SEAT MODIFICATION

B/C SEAT MODIFICATION

SIZE	DWG NO.	REV.
A	AC1604211MOD	N/C
SCALE NONE		SHEET 1 OF 1

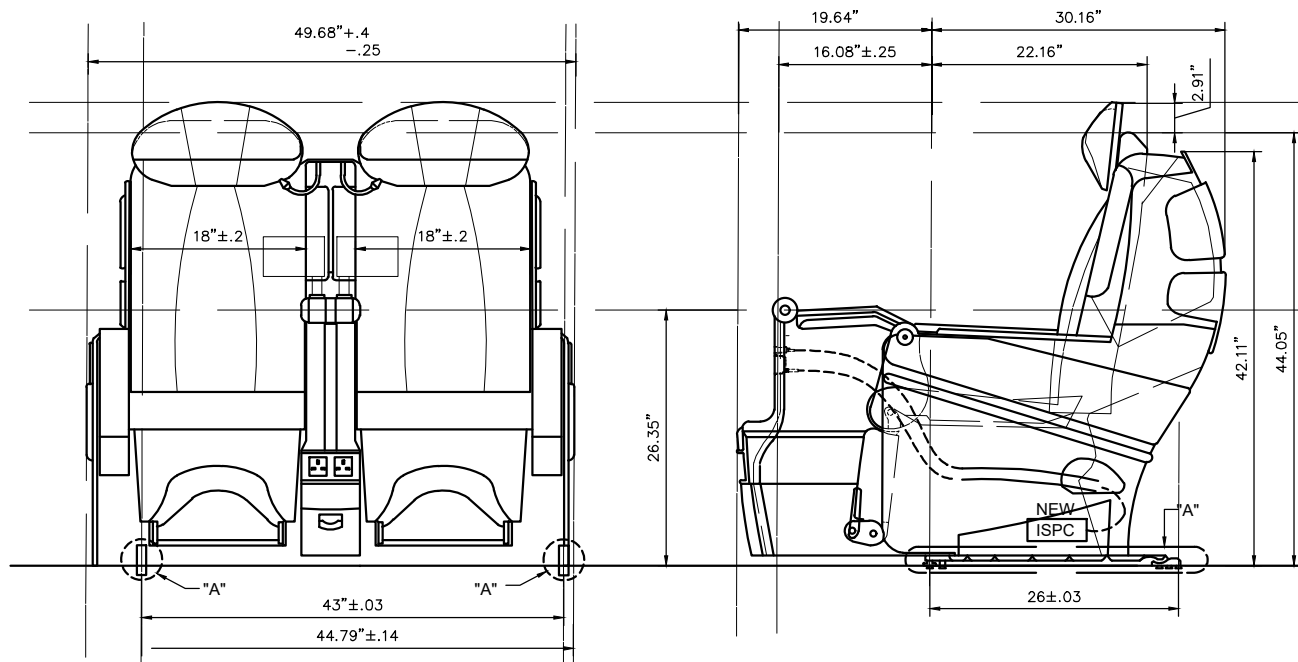
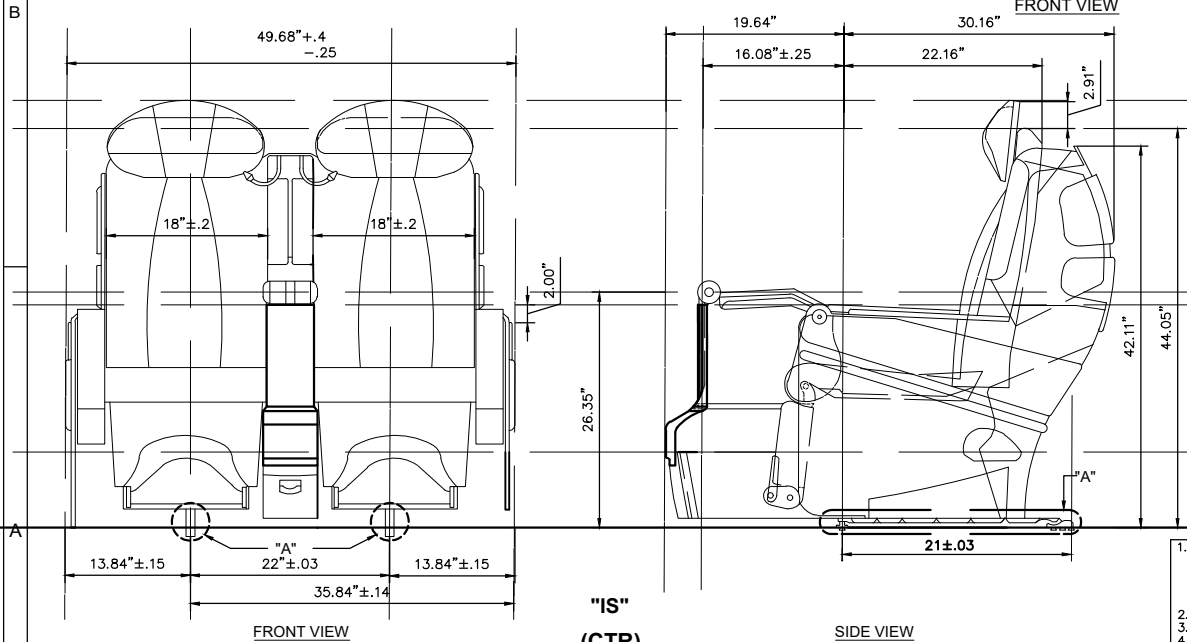
**"WAS"
(LH)**

**"IS"
(CTR)**

1. REFERENCE CMM 25-00-77
2. REPLACED REINFORCED TRACK "A" WITH P/N:16-100100-720-0AC.
3. SEAT WILL BE MODIFIED BY MOVING LEG DISTANCE SPECIFIED TO FIT B767 CENTER SEAT.
4. ALL MATERIAL AND HARDWARE ARE RE-USED AS REQUIRED.
5. REMOVED IFE's ,POWER OUTLETS AND FRONT RING FAIRING.
6. COVER THE IFE PROVISION WITH FRONT RING FAIRING PN:AC1604-55, USING EPOXY ADHESIVE CLEAR DP100 UPON REMOVAL OF IFE's AND POWER OUTLETS.
7. INSTALL SEAT BELT P/N: 2010-1-511-2849.
